APPLICATION FOR LAND USE CONSISTENCY DETERMINATION
San Mateo County Airport Land Use Commission
C/CAG ALUC

Agency:	City of South San Francisco		
Project Name:	Gateway of Pacific Phase 4 Density Transfer Project		
Address:	900 Gateway Blvd	APN:	015023450
City:	South San Francisco	State:	CA
		ZIP Code:	94080
Staff Contact:	Billy Gross	Phone:	650-877-8535
		Email:	billy.gross@ssf.net

Subject: Application for Land Use Consistency Determination for Gateway of Pacific Phase 4 Density Transfer Project, South San Francisco

Exhibit IV-17
CRITICAL AERONAUTICAL SURFACES
 -- NORTHWEST SIDE
 Comprehensive Airport Land Use Plan
 for the Environs of San Francisco International Airport
C/CAC
 City/County Association of Governments
 of San Mateo County, California

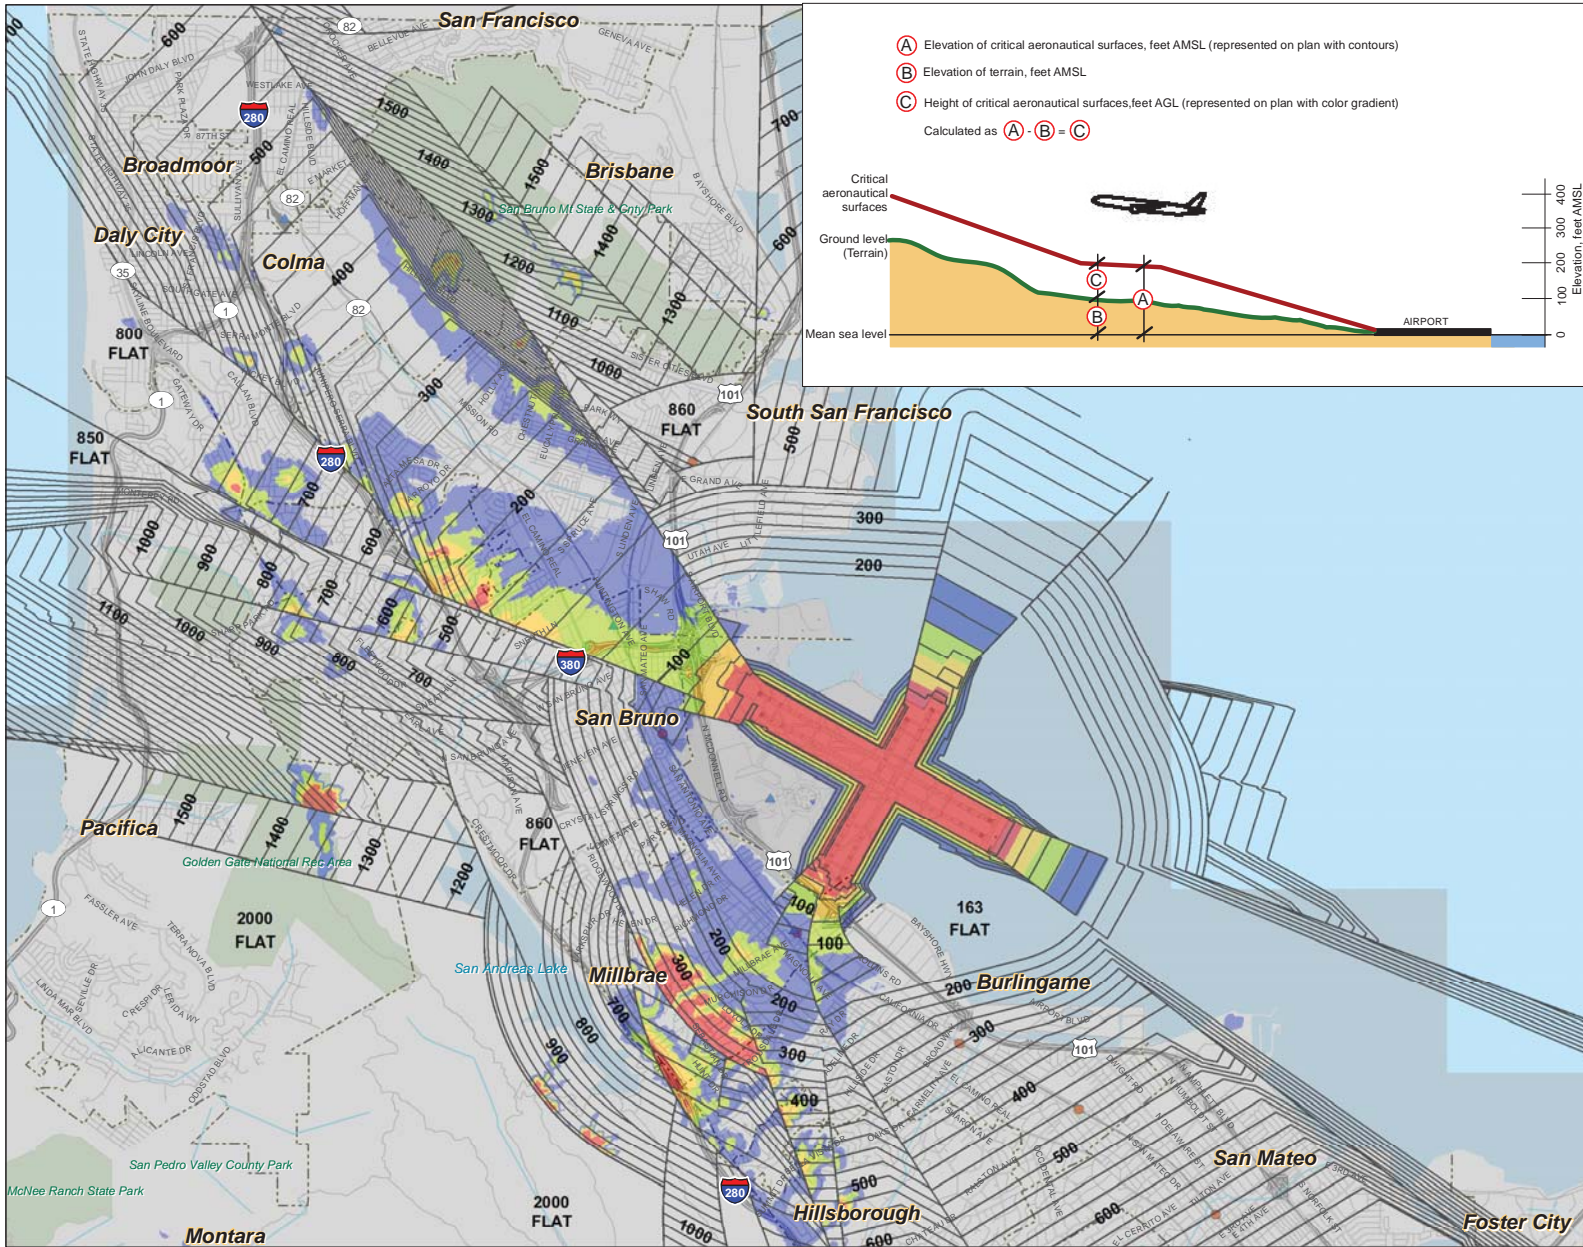
As depicted on Exhibit IV-17 of the SFO ALUCP (see Attachment), the critical aeronautical surfaces above the Proposed Project are at an elevation of between approximately 510 and 540 feet above mean sea level (AMSL) as defined from the origin of the North American Vertical Datum of 1988 (NAVD88). Thus, the estimated maximum elevation of the Proposed Project (217 feet NAVD88) would be below the critical aeronautical surfaces and the Proposed Project would not appear to be incompatible with the Airspace Compatibility Policies of the SFO ALUCP, subject to the issuance of a Determination of No Hazard from the Federal Aviation Administration (see below) for any proposed structures and determinations from the City/County Association of Governments of San Mateo County as the designated Airport Land Use Commission. While not it does not affect this review, the applicant incorrectly cites ALUCP Exhibit IV-14,

which depicts 14 CFR Part 77 Airport Imaginary Surfaces, as limiting building heights in the area. Instead, the correct exhibit should be ALUCP Exhibit IV-17 (attached), which depicts the critical aeronautical surfaces that should not be exceeded. Nevertheless, the Proposed Project height would still be below the critical aeronautical surfaces.
